**Brooklyn Inland Wetlands Commission**  
**Special Meeting Agenda**  
**Tuesday, July 11, 2023**  
**Zoom and In-Person Meeting**  
**Community Center**  
**31 Tiffany Street Upper Level**  
**6:00 p.m.**

**Brooklyn Inland Wetlands Commission**  
**Regular Meeting Minutes**  
Tuesday, June 13, 2023  
Zoom and In-Person Meeting  
Clifford B. Green Memorial Center  
69 South Main Street  
6:00 p.m.

The comments contained herein pertain to my review of a set of plans, consisting of fifteen (15) sheets (sheet 15 architectural missing), entitled "Special Permit Site Development Plan Prepared for Townsend Development Associates, LLC, Providence Road (Route 6), Brooklyn, Connecticut, Dated: May 5, 2023, Revised: N/A," prepared by CHA and Drainage Report, dated May 24, 2023, by CHA.

### **Drawing No. 2 (Sheet 1 of 1) – Improvement Location Plan**

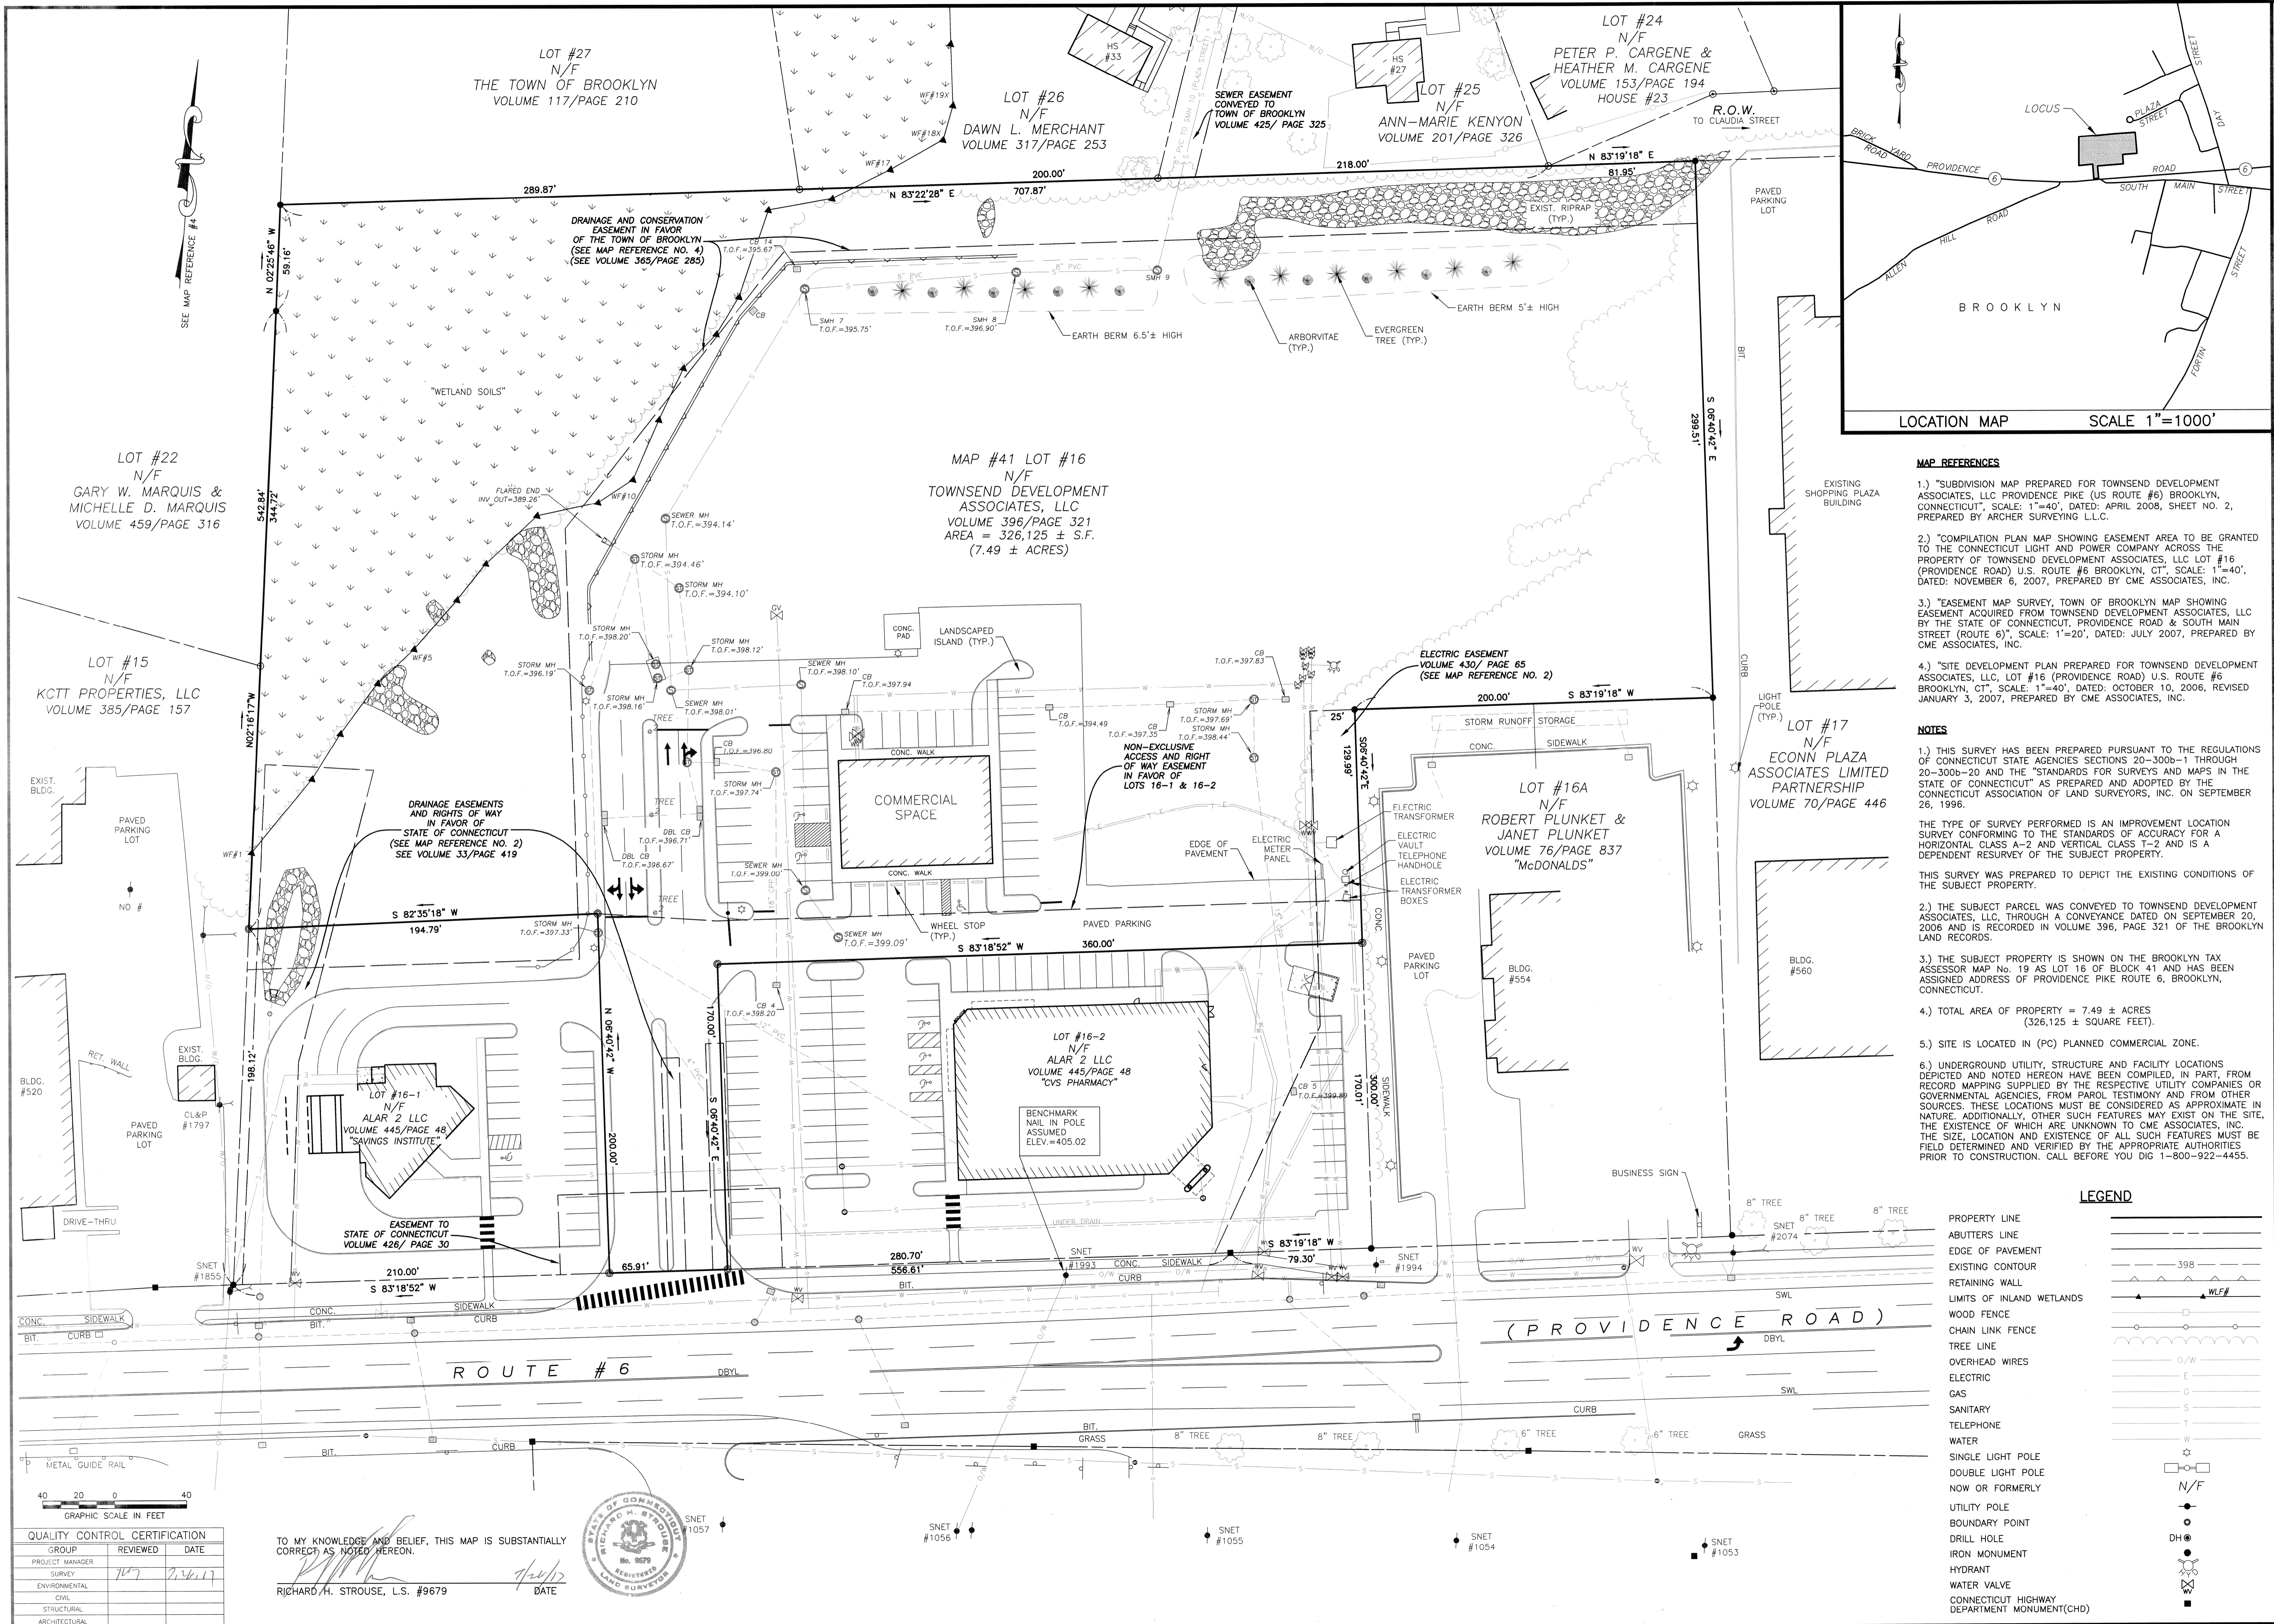
1. Not all sidewalks shown are dimensioned. All sidewalk widths need to be specified on the plan.
2. If the sidewalk at the south end of the proposed crosswalk is not flush with the pavement, a sidewalk ramp will need to be constructed there and a construction detail provided — see Type 17 on CT DOT "Sheet 6 – Sidewalk Ramps."

(CT DOT) 48" wide ramp with landing detail drawing that can be found on their "Sheet 1 - Sidewalk Ramps."
